CITY COMMENTS #1	26.04.24
Permit	26.02.13
90% OWNER REVIEW	25.12.16
ISSUANCE	DATE

Marten's Residence Addition

Plot Plan

AS1.1

1 PLOT PLAN
SCALE: 1" = 20'

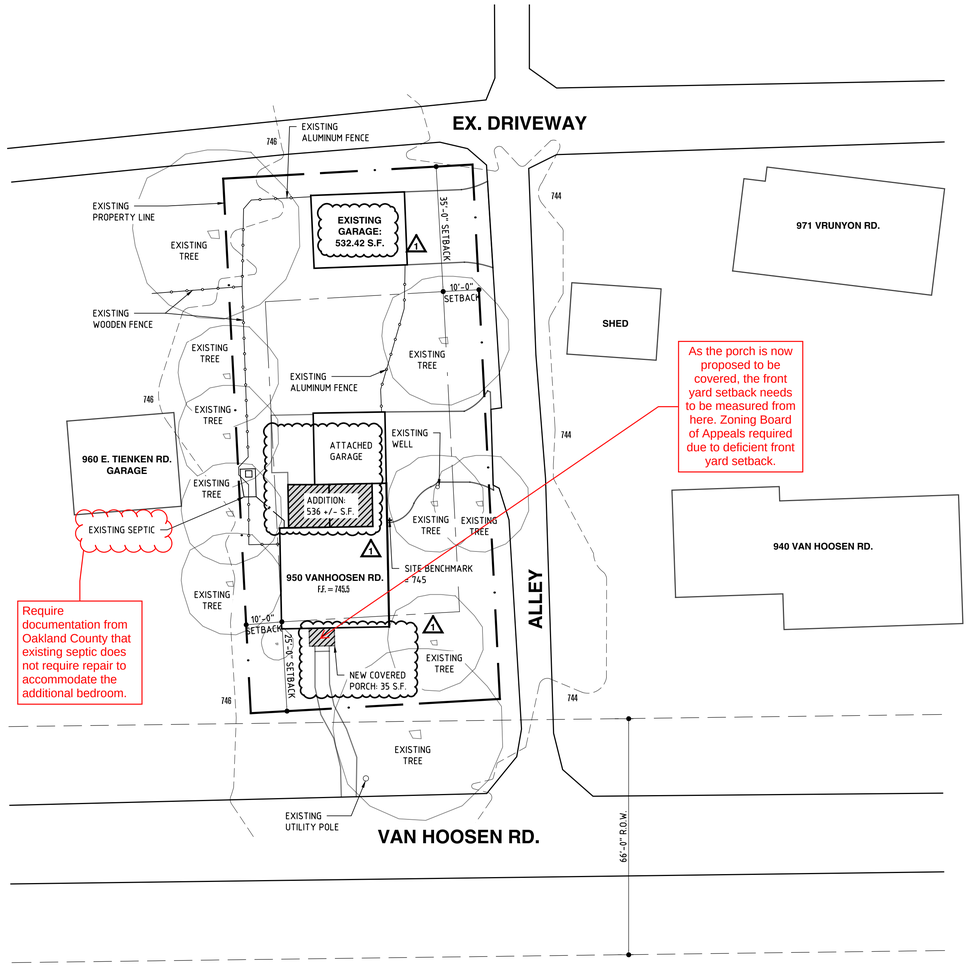
As the porch is now proposed to be covered, the front yard setback needs to be measured from here. Zoning Board of Appeals required due to deficient front yard setback.

Require documentation from Oakland County that existing septic does not require repair to accommodate the additional bedroom.
